External Body Service Lift Bolt Installation for Meridian FEL

Date: August 30, 2017
Bulletin Name: FEL-TSIB-050
Models: Meridian FEL 78
Model Year: 2015-2017
Units Affected: Vehicles with external body service lifts

Figure 2

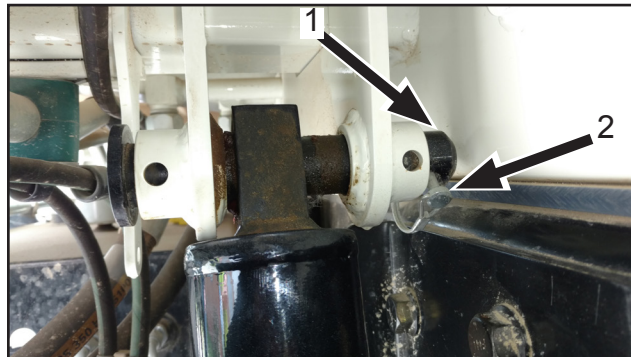
3. Inspect if the cylinder pin (Figure 2, Item 1) is installed for the upper cylinder assembly. (Inspect both service lift cylinder assemblies.)
 - If the cylinder pin is missing or damaged, order the replacement part before proceeding with this installation instruction. Vehicle cannot be used in service until all parts are installed.
4. Remove the round snapper pin (Figure 2, Item 2) from the upper pin on the body lift cylinder. Discard the snapper pin.

Figure 3

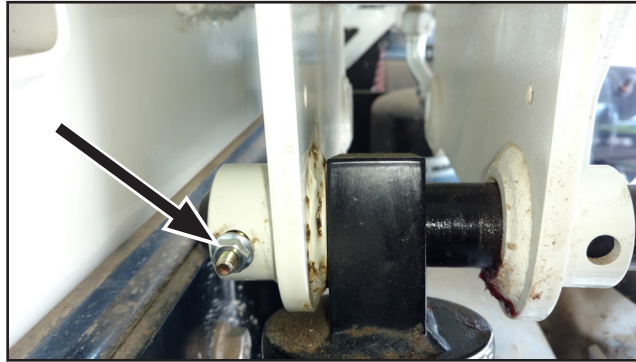
6. Insert the bolt through the hole on the collar of the body lift lug and cylinder pin (Figure 3).
7. Install the nut and tighten until it is secure on the bolt using the impact wrench.
8. Repeat Steps 4 through 7 to the service lift cylinder on the other side of the vehicle.
